AGENDA
CITY OF MONTEVALLO
PLANNING AND ZONING COMMISSION

REPORT TO THE CITY OF MONTEVALLO

Case No. SP19-008

Case No. SP20-001 Dollar General - Hwy 25 Site Development Plan

DRAWN BY:	JAC
DATE:	11-12-2019
REVISED:	03-24-2020
SITE PLAN	
SHEET 4 OF 19

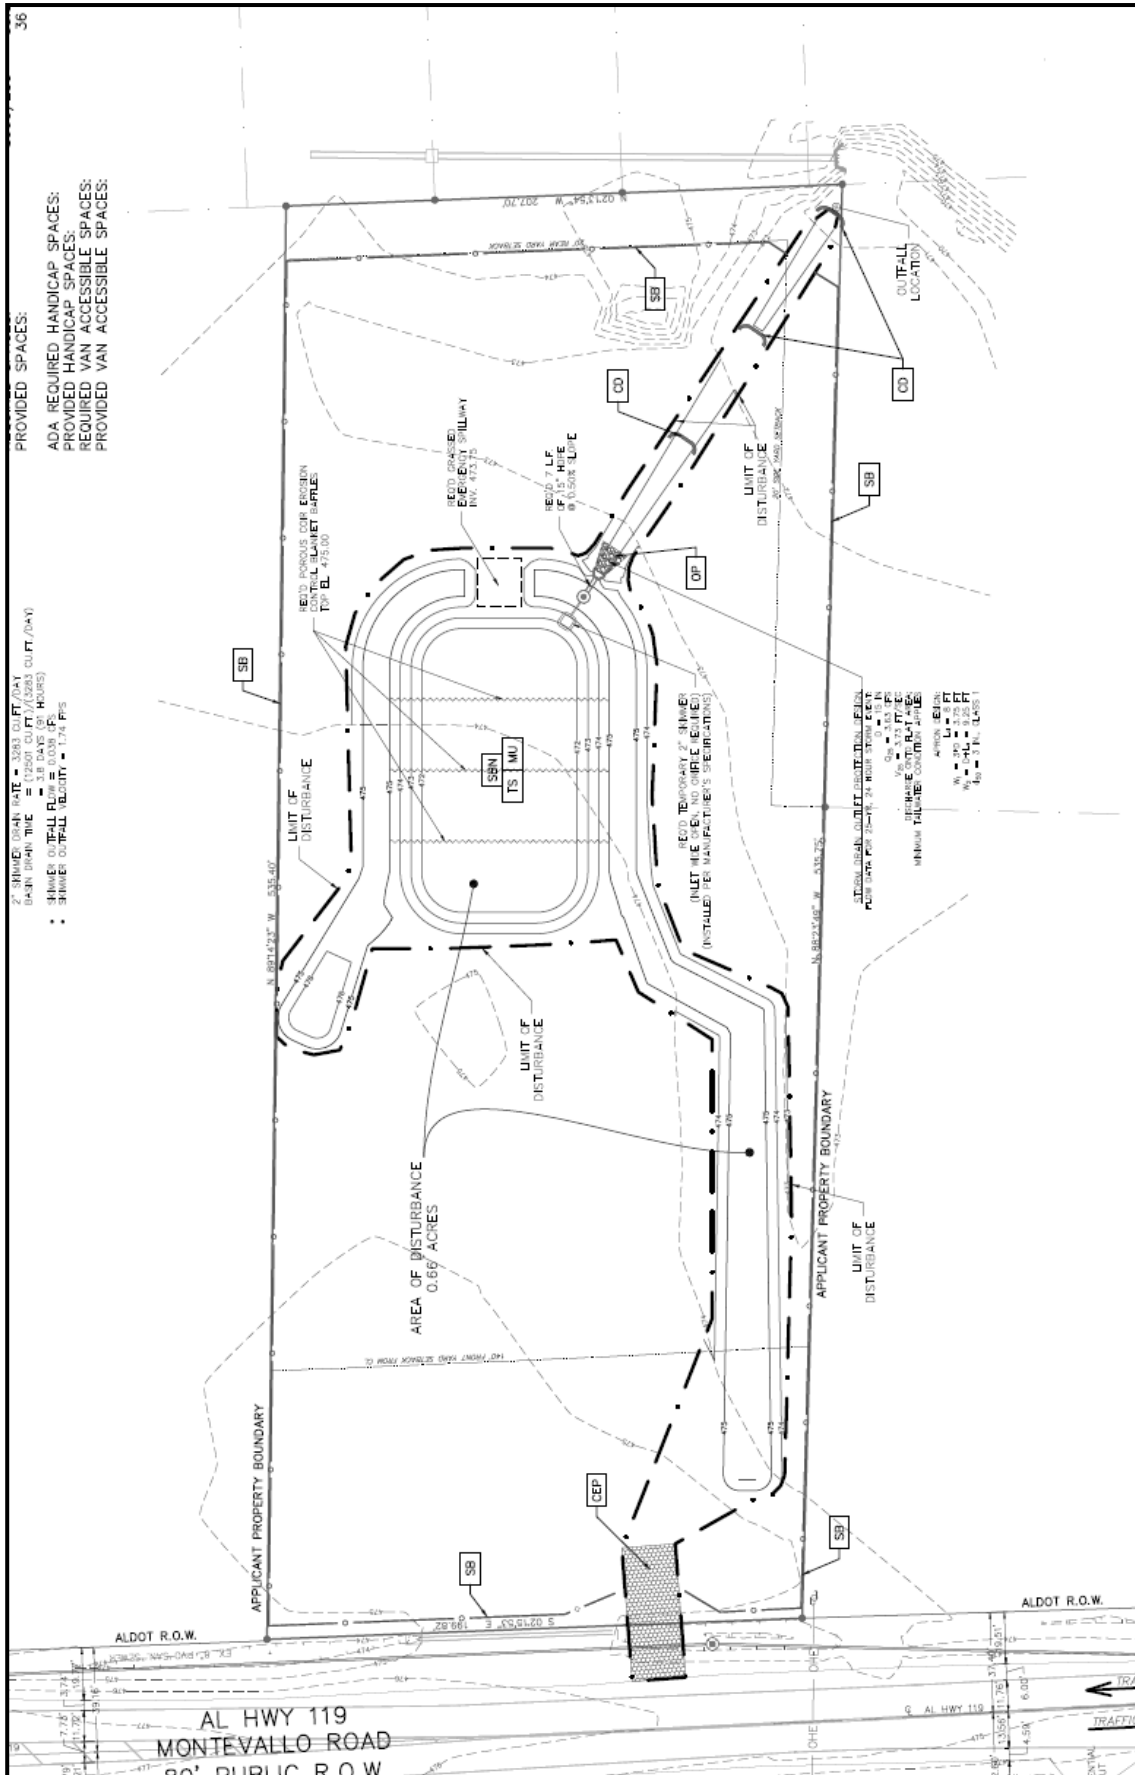
1. The site benchmark per the Schoel land title survey must be added to sheets 4, 8, 10 & 13.
2. An approved ALDOT Turn-Out permit must be provided prior to commencement of project construction.
3. A Land Disturbance Permit and bonding must be approved and in place including evidence of an ADEM General NPDES coverage.

DRAWN BY: JAC
 DATE: 12-30-2019
 REVISED: 03-24-2020
 STORMWATER MANAGEMENT PLAN
 SHEET 8 OF 16

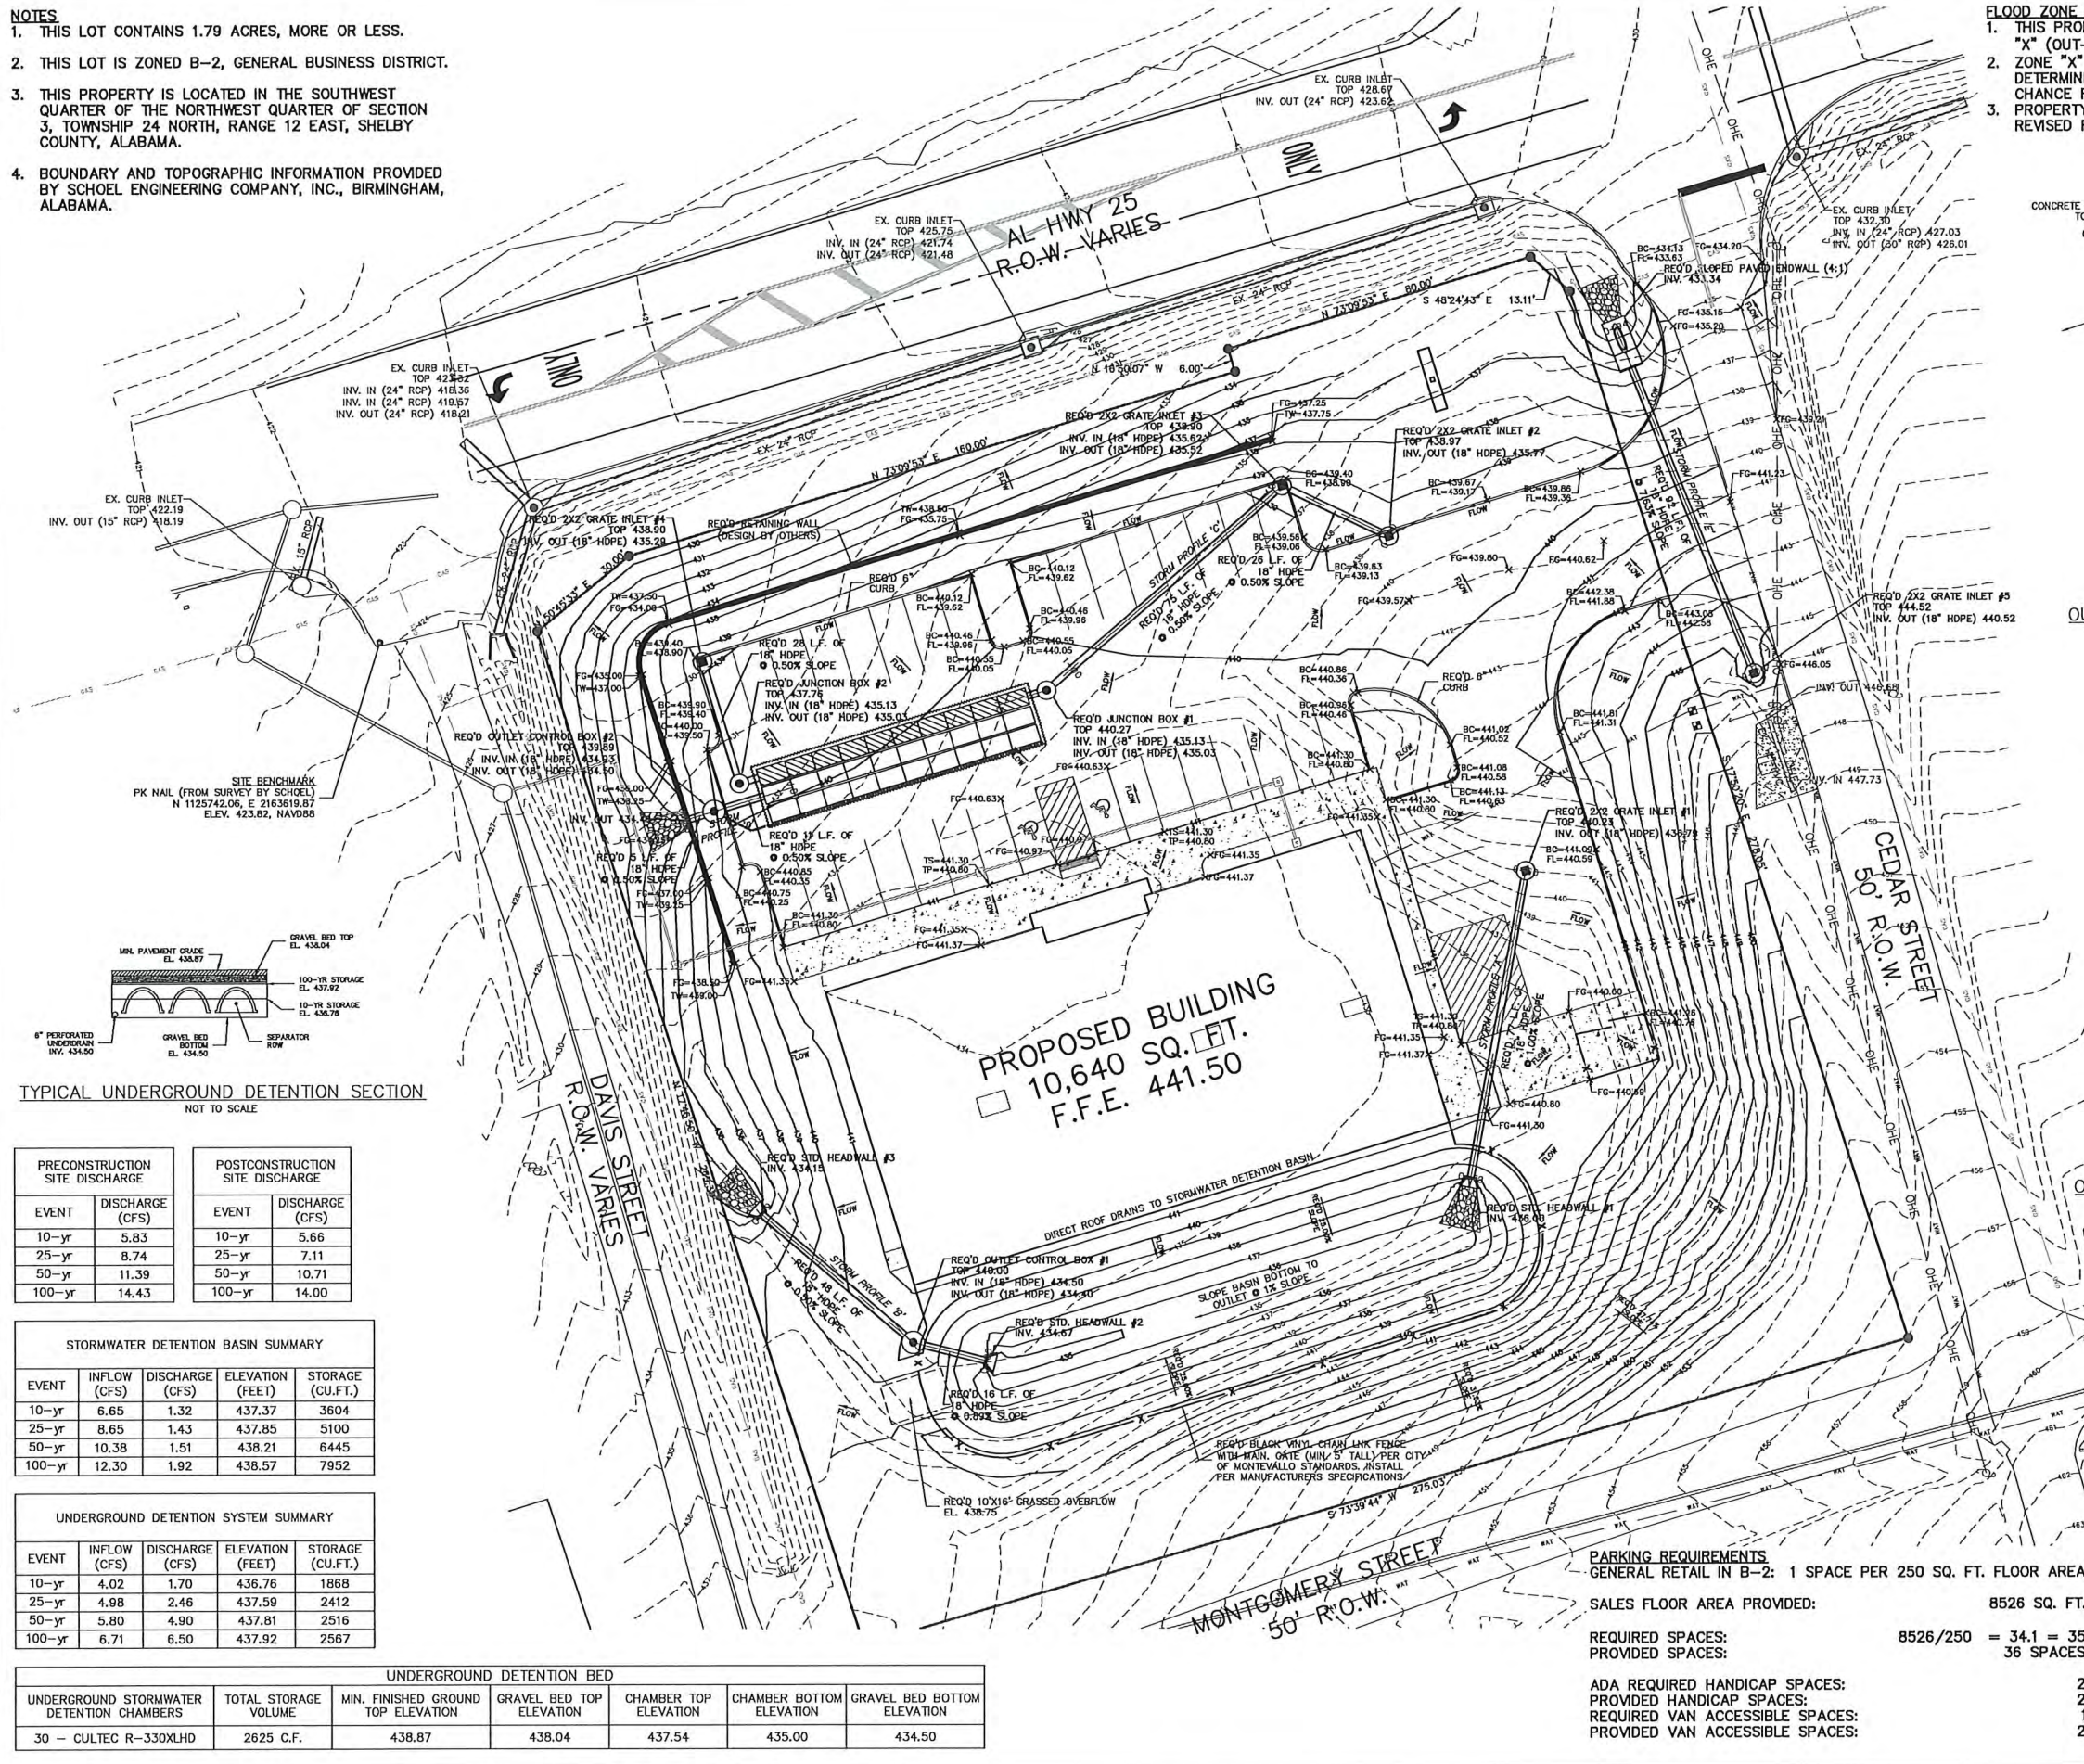
1. Please include the horizontal coordinates and vertical elevation data in the plans for the benchmark shown on the provided land title survey.
2. Correction of minor typographical error on Note No. 8 in the "Earthwork General Notes"
